INTERAGENCY MEMORANDUM

Re: NorthMet Environmental Impact Statement
Co-lead Agencies' Response for GLIFWC Comments on Calibration of the Mine Site MODFLOW Model to Partridge River Groundwater Baseflows

July 10, 2015

Figure 2 GLIFWC Summary Illustration from June 18, 2015 Correspondence

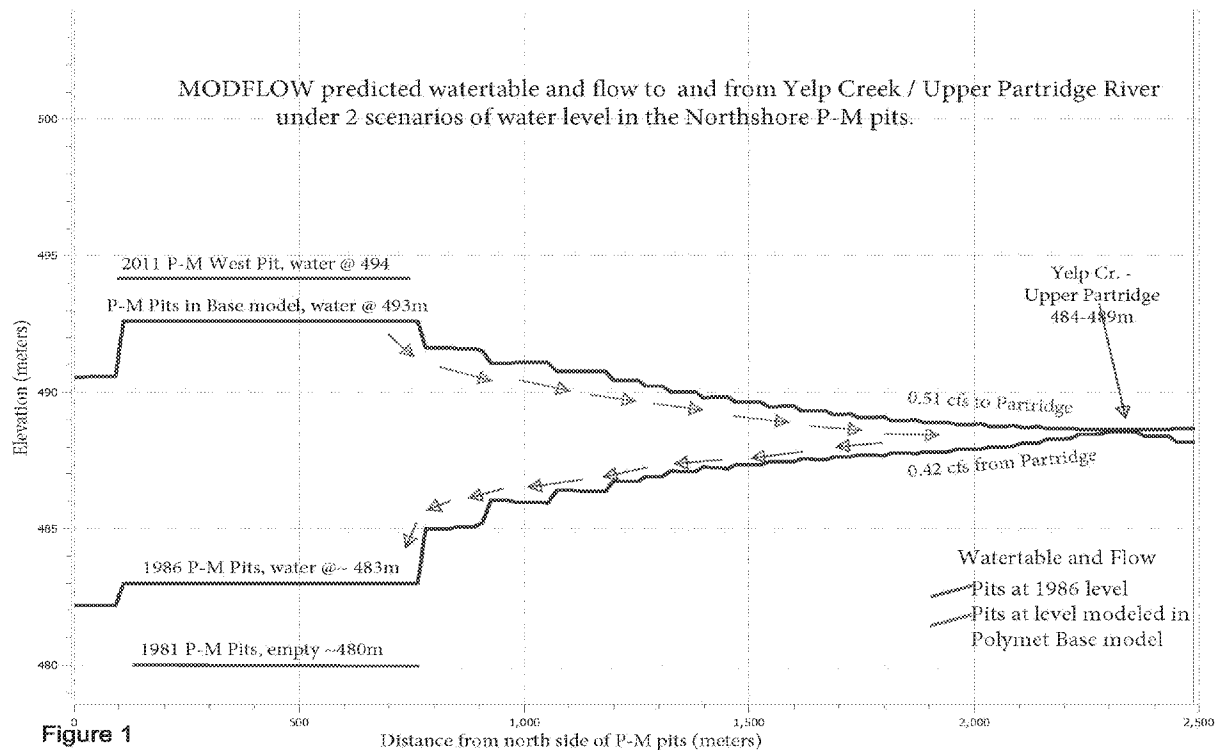
For groundwater baseflows, the GLIFWC letter raised concerns about the use of 1980s stream gaging data at SW-006 to calibrate the FEIS MODFLOW model, which is intended to represent recent conditions. Due to low pit water levels at Northshore's operations during this time period, GLIFWC contends that groundwater baseflows interpreted from 1980s data are lower than the current groundwater baseflows. GLIFWC concludes: "The result of this mis-match of boundary conditions and calibration targets is that the model is incorrectly calibrated and can not be expected to produce accurate information."

The Co-lead Agencies' review of the summary illustration attached to the GLIFWC letter (Figure 2 herein) suggests that during the 1980s, the Northshore pits intercepted approximately 0.93 cfs of groundwater that otherwise would have become groundwater baseflow to the Partridge River. The Co-lead Agencies further interpret the GLIFWC line of reasoning to suggest that groundwater baseflow at SW-006 could currently be 0.93 cfs higher than the value listed in Table 1, and this would give an Upper Partridge River groundwater baseflow yield of 0.064 cfs/mi², which is approximately 18% higher than the FEIS value (0.054 cfs/mi²). Applying this higher groundwater baseflow yield (derived from GLIFWC's assumptions) to the other MODFLOW calibration stations would lead to the values summarized in Table 2.

Whereas the Co-lead Agencies continue to consider the Table 1 groundwater baseflows as reasonable values that should be retained for FEIS modeling, the *possibility* that the Table 2 values could exist for current conditions is acknowledged. In this context the Co-lead Agencies note the GLIFWC letter further states:

The Co-lead Agencies do not consider GLIFWC Option #1 to be a viable option because other calibration data, such as measured groundwater levels in surficial deposits and bedrock, would be limited or nonexistent for the mid-1980s time period. The Co-lead Agencies do consider GLIFWC Option #2 to be a workable approach for investigating the effect of higher groundwater baseflows on predicted water quality and quantity effects associated with the NorthMet Project Proposed Action. If pursued, GLIFWC Option #2 would increase the groundwater baseflows at all locations used to calibrate the MODFLOW model by a factor of 2.5 to 3.5 times higher than the groundwater baseflows used to calibrate the FEIS model (listed in Table 1). This is also much higher than the approximately 18% increase interpreted from the illustration attached to the GLIFWC letter (See Figure 2).
